Product Change Notification

PCN-PCC-7334-2021

Business Unit	Product Line Code	Type of Change	Action	Date of Issue
PCC - PCB Connectors	AAA	Product Change Notification	Notify Distributors and Field	10/25/2021

Description for Product Change Notification

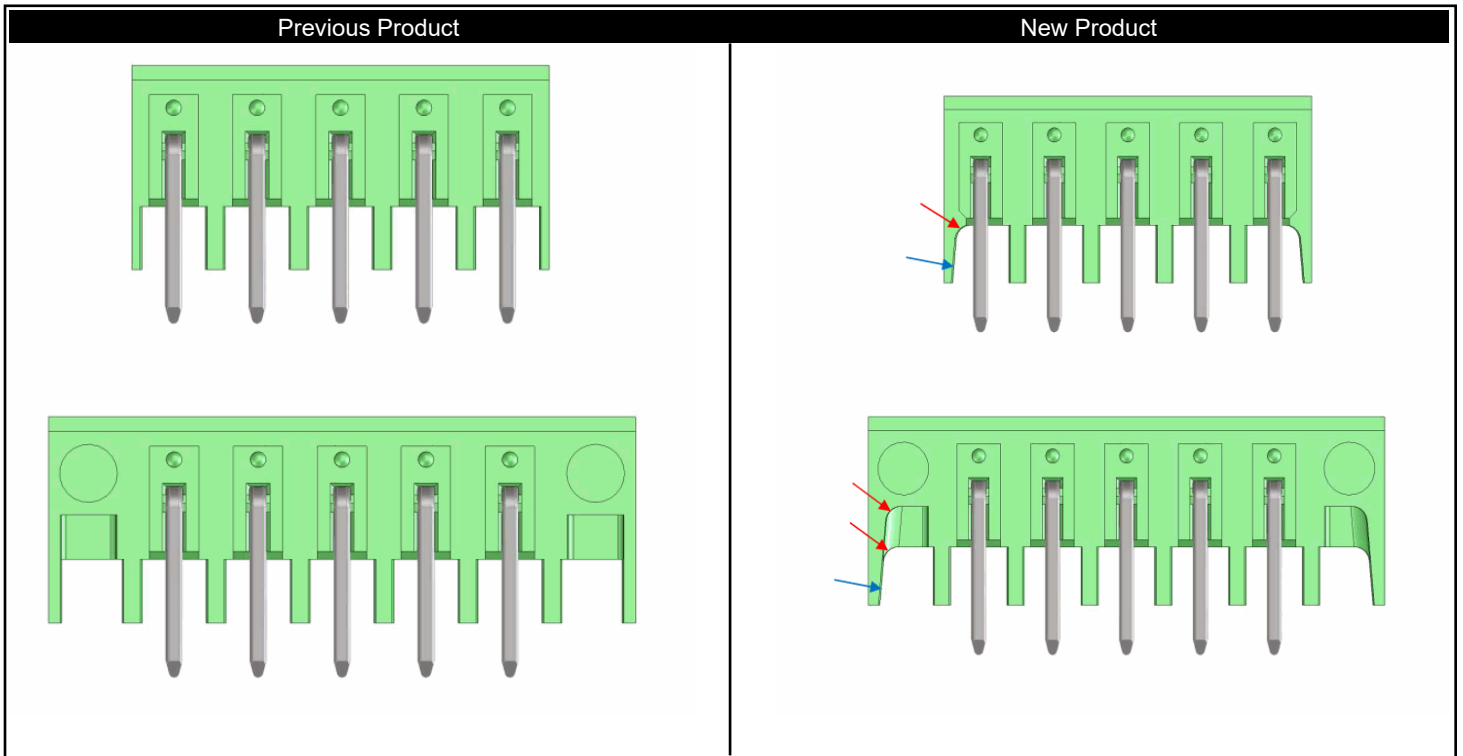
As part of ongoing improvement measures, the external walls of the MSTBW 2,5 headers will be reinforced in order to create more stable external walls. In the attached image, blue arrows indicate the new draft angles and red arrows indicate the transition radii. The external dimension, pin layout, and electrical data remain unchanged. The effective date of this change is May 1st, 2022.
